Red dash line indicates extent of amendments to address RFI 0723 dated 08 JUNE 2022

PROJECT
ADAMSTOWN STATION BLOCKS ACD

DRAWING
APARTMENT TYPES KEY PLAN
BLOCK D

STATUS CODE: A1 DRAWING NUMBER: ADC3-HJL-ACD-ZZ-DR-A-P8000 REVISION: P02

1 APT TYPES BLOCK D - LEVEL 00 - P
1 : 500

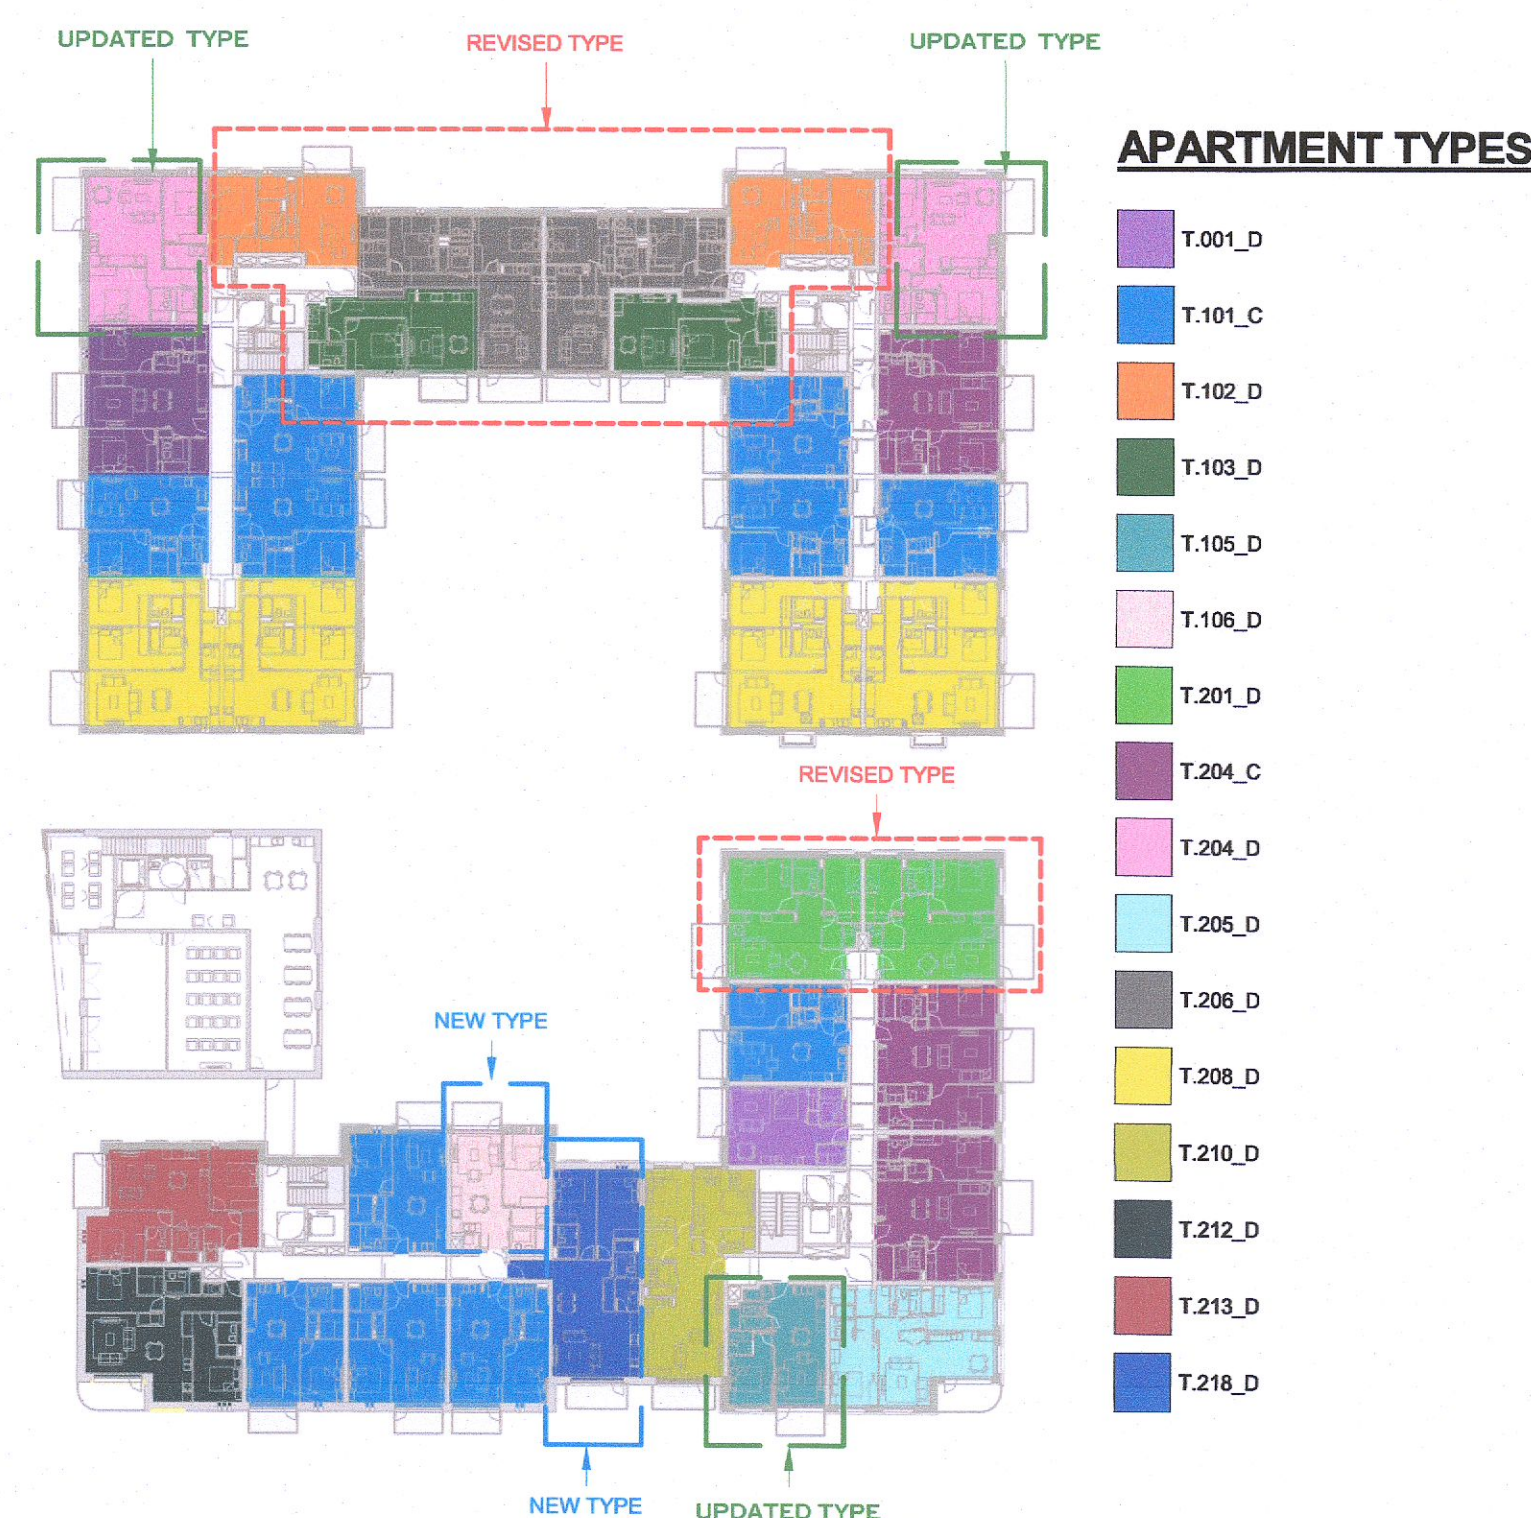
RFI 1 (a)
Block D North - Changes to Core entrance hall facing Great Western Way updated to accommodate new apartment type T.301_D revised apartment type T.102_D

RFI 1 (b)
Block D South - Changes to apartment type T.201_D and T.202_D to overcome privacy/overlooking issues

4 APT TYPES BLOCK D - LEVEL 03 - P
1 : 500

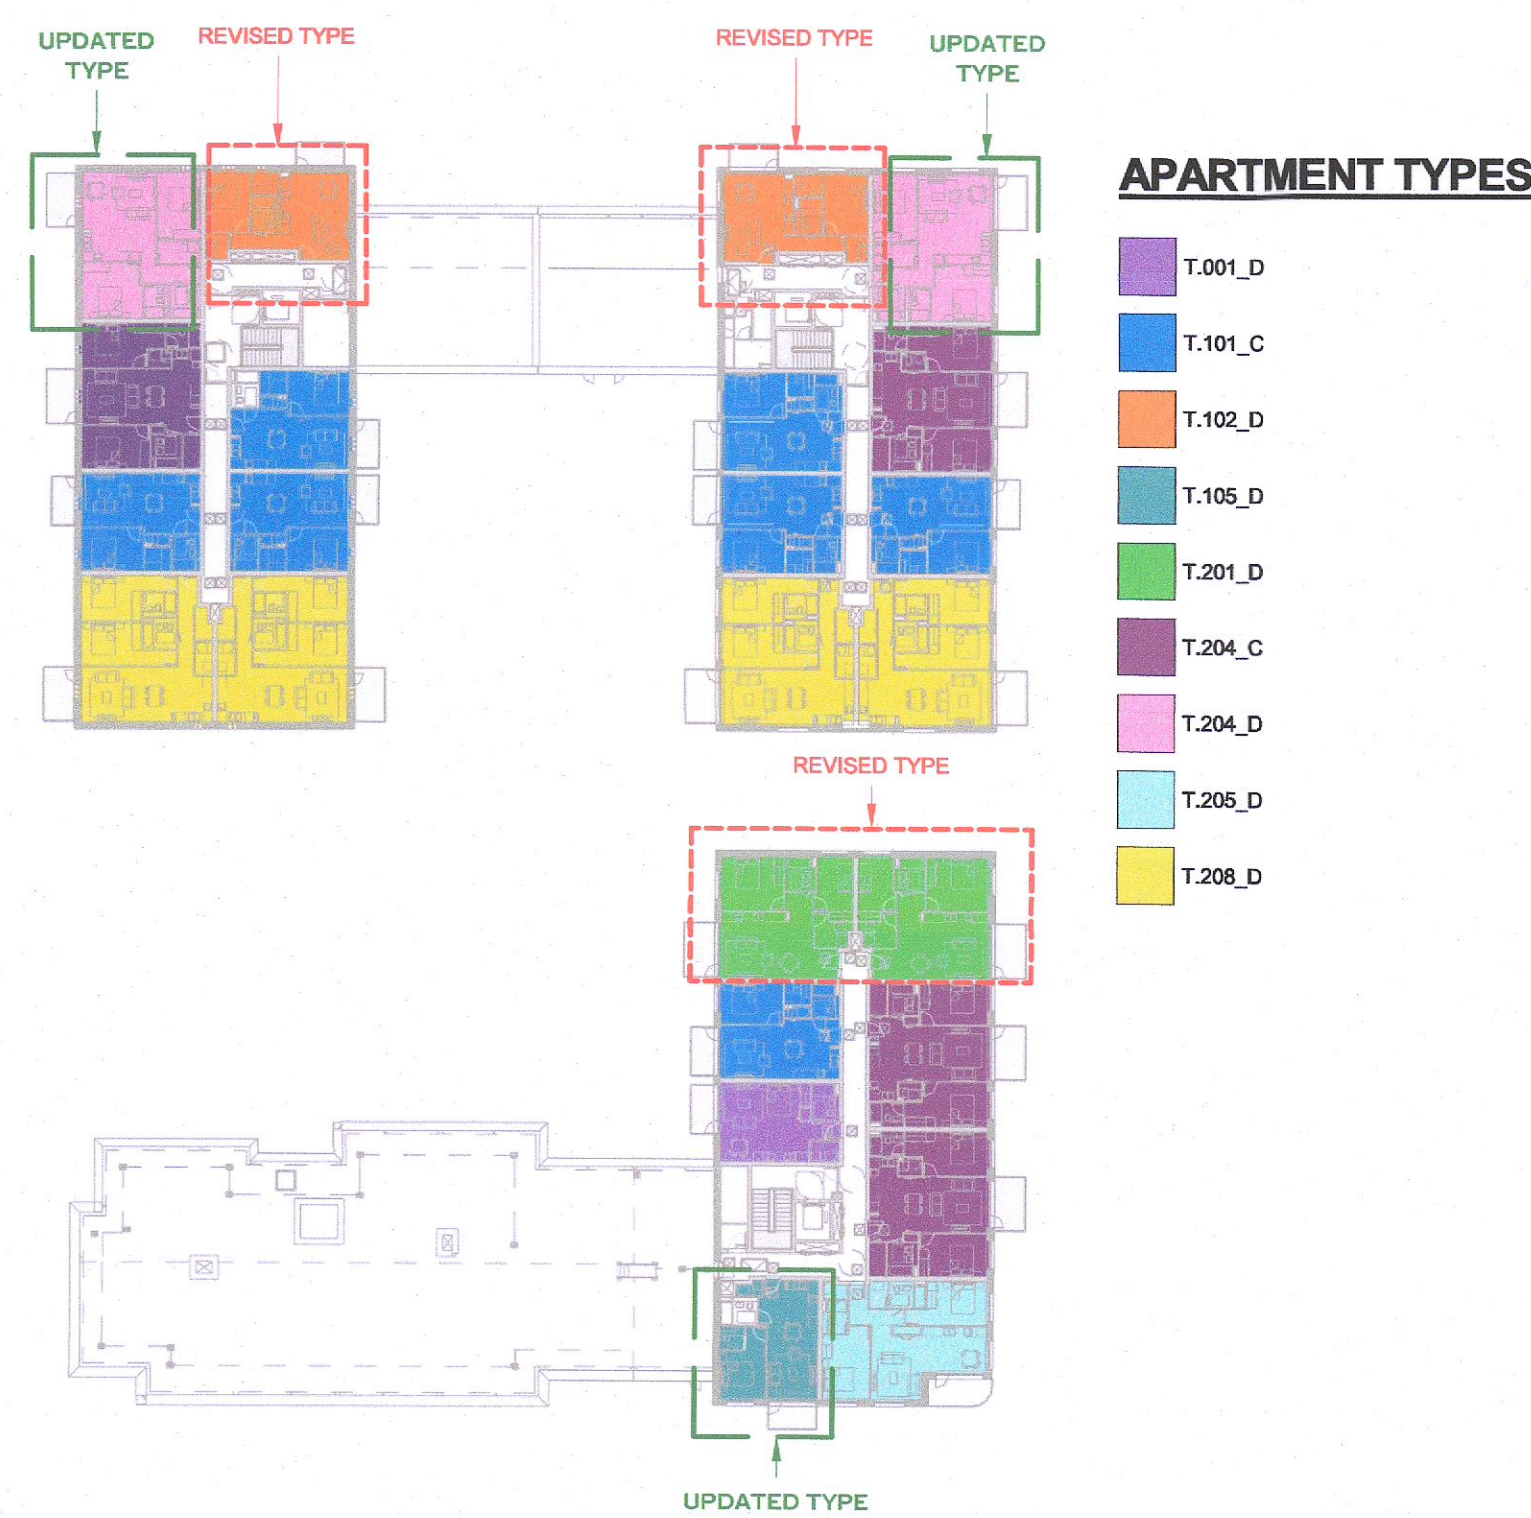
RFI 2
Block D South - Changes to facade material to brick on the upper floor levels
